ADDENDUM No. 3 TO PROCUREMENT CONTRACT DOCUMENTS
BRIDGEPORT PUBLIC UTILITY DISTRICT (BPUD)

Arsenic Removal Project – Arsenic Removal System Procurement Contract

May 17, 2017

Bridgeport Public Utility District – Arsenic Removal Project

UTILITY PLAN

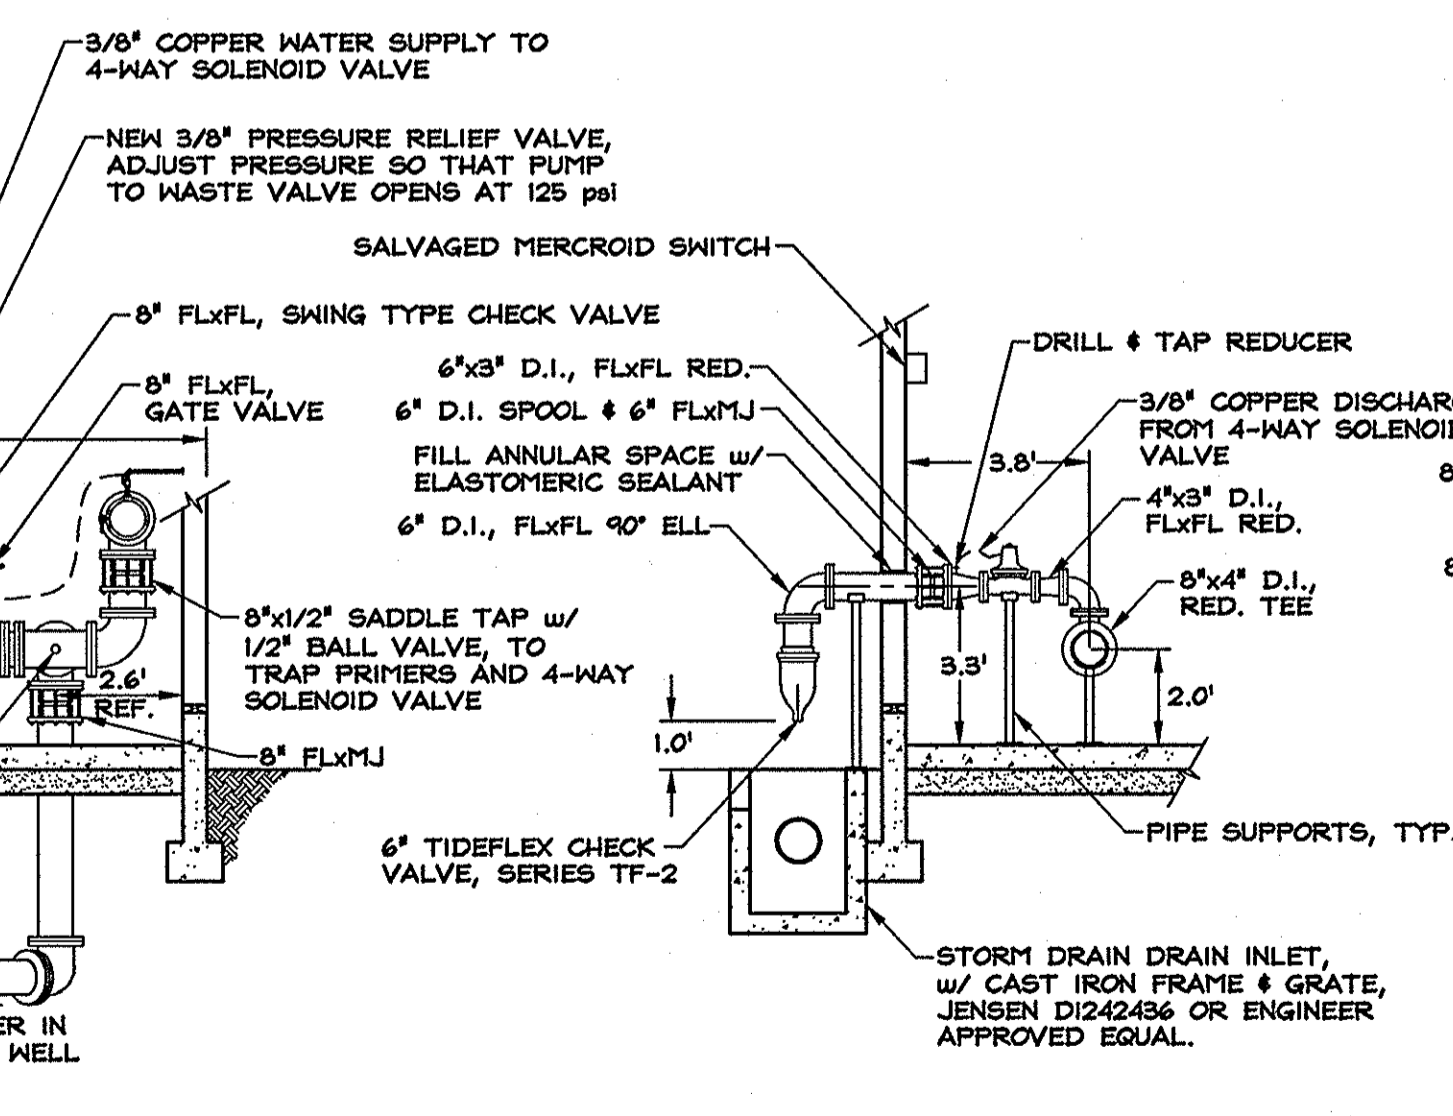
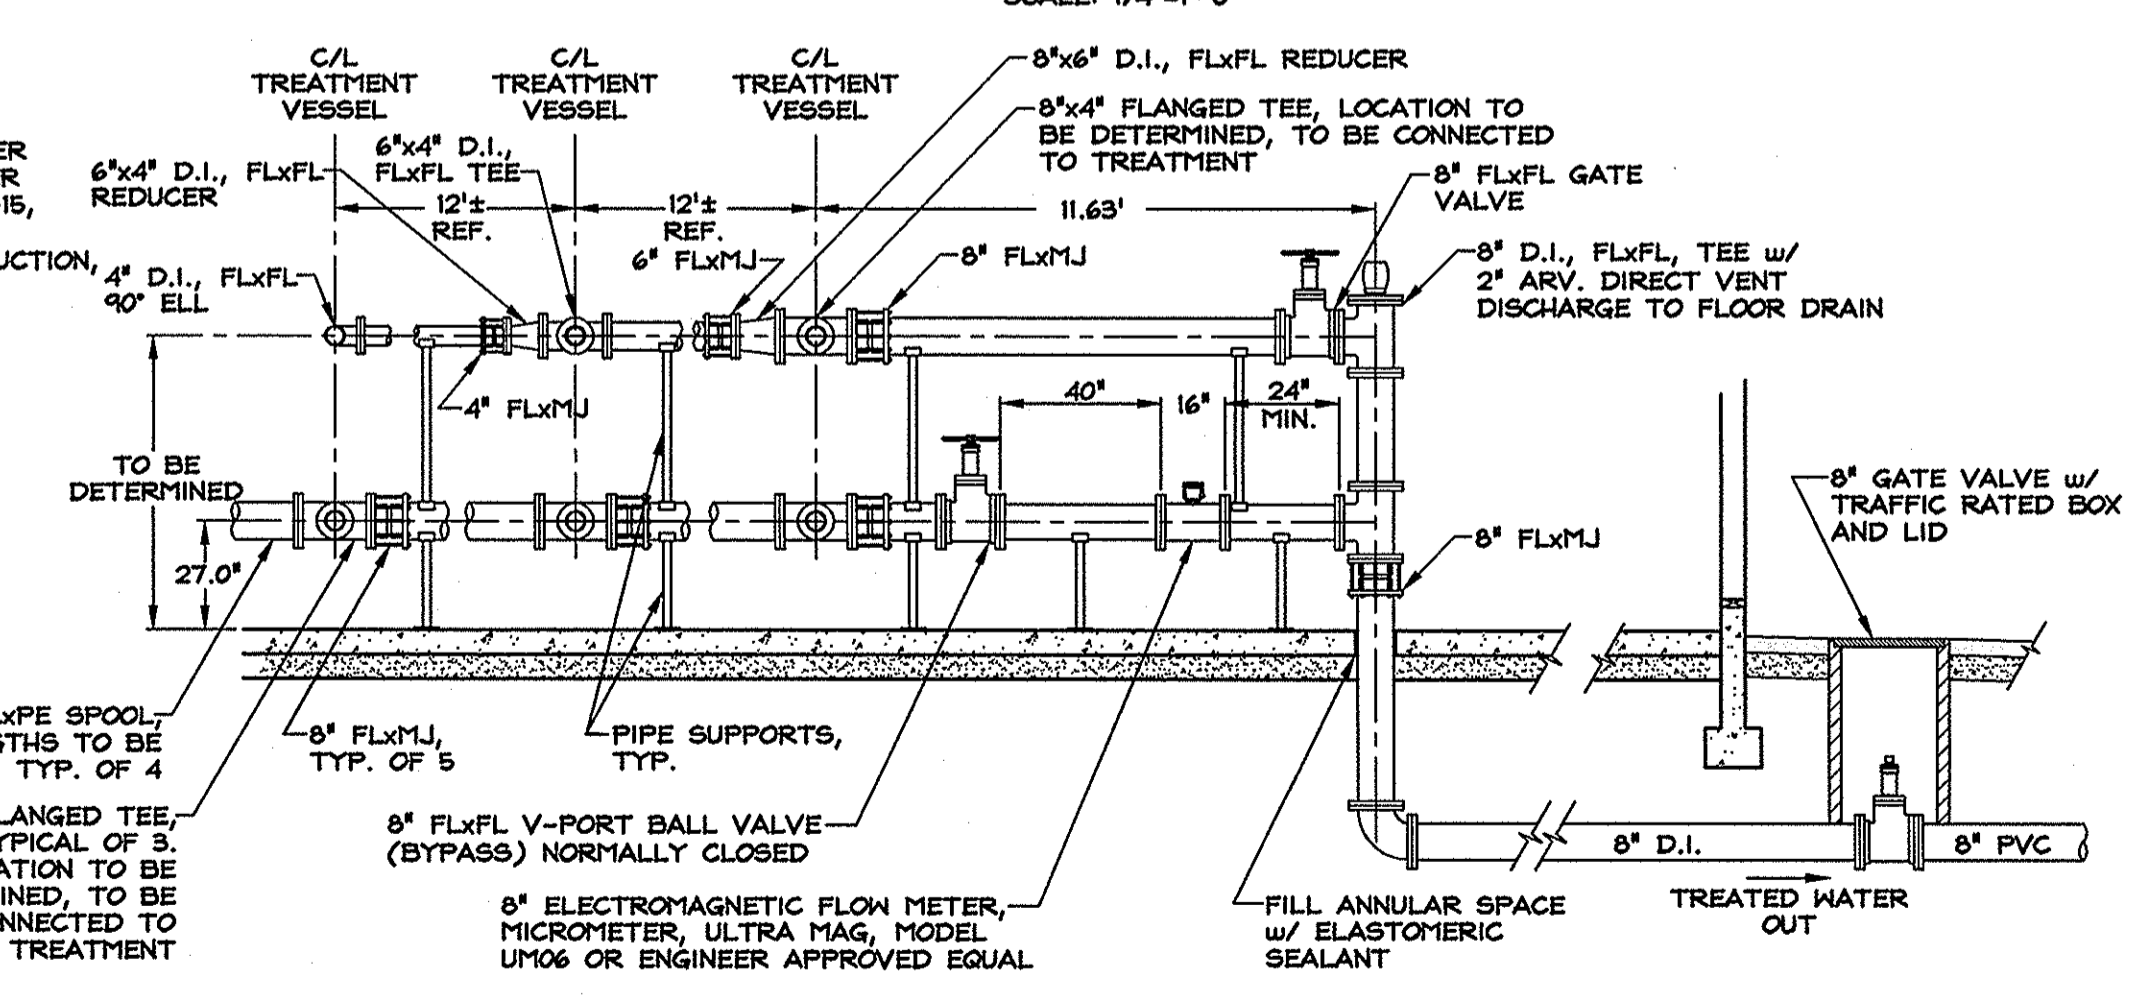
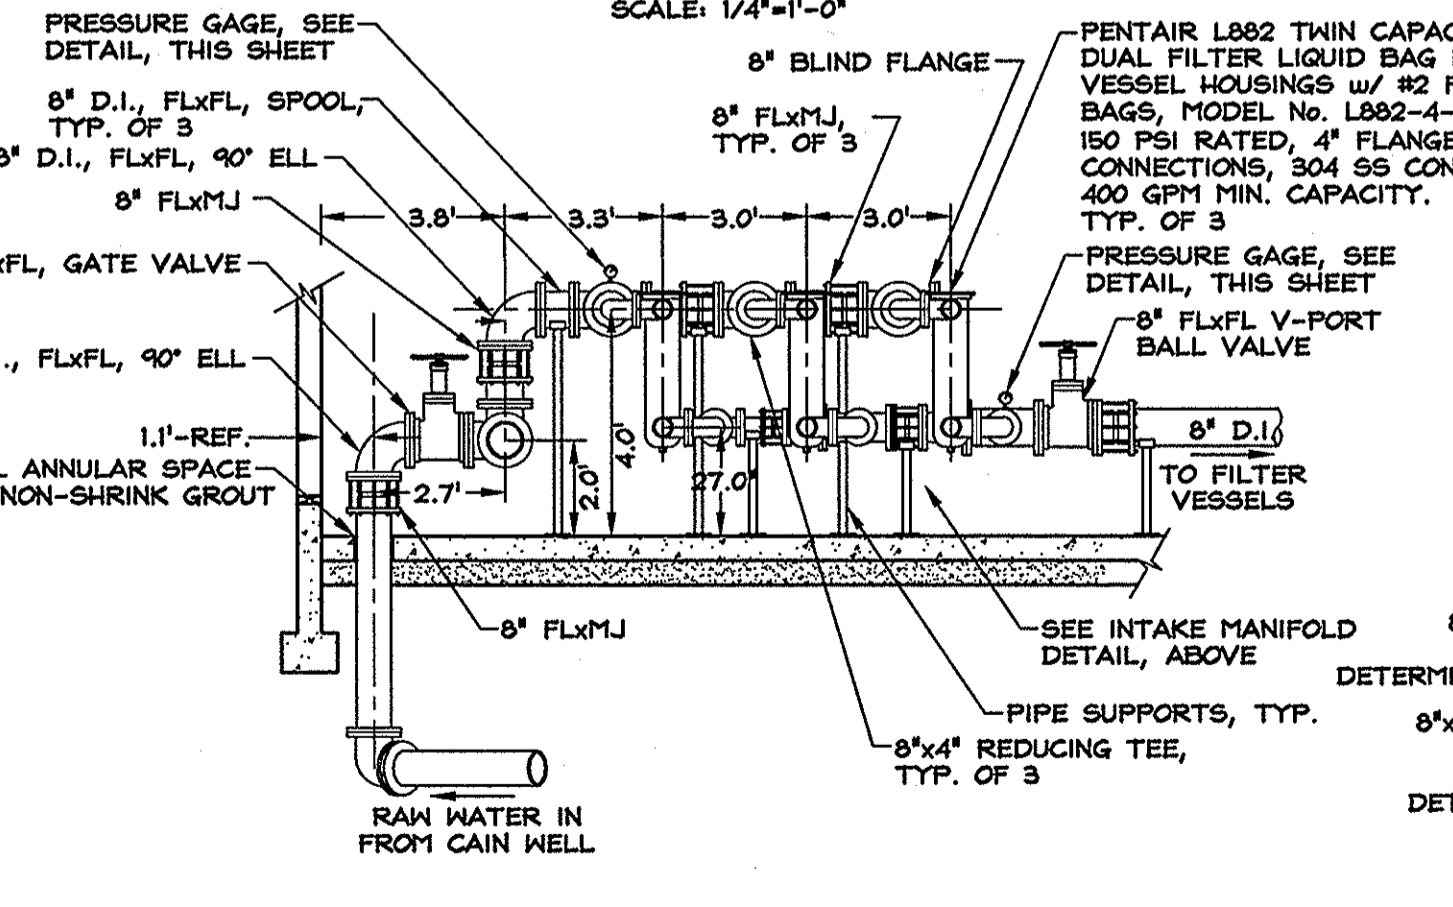
1. Addition of note pointing to the spacing in front of the new electrical panel that reads: “30” Minimum clear space is required in front of electrical panels”.
2. Addition of illustration of the piping from the bag filters to the new vessels to match the Section D-D Detail.
3. Previous connection from the Twin Lakes Well existing underground raw water line to new treatment building will now connect inside the new Twin Lakes Well house to the rotated pump discharge.
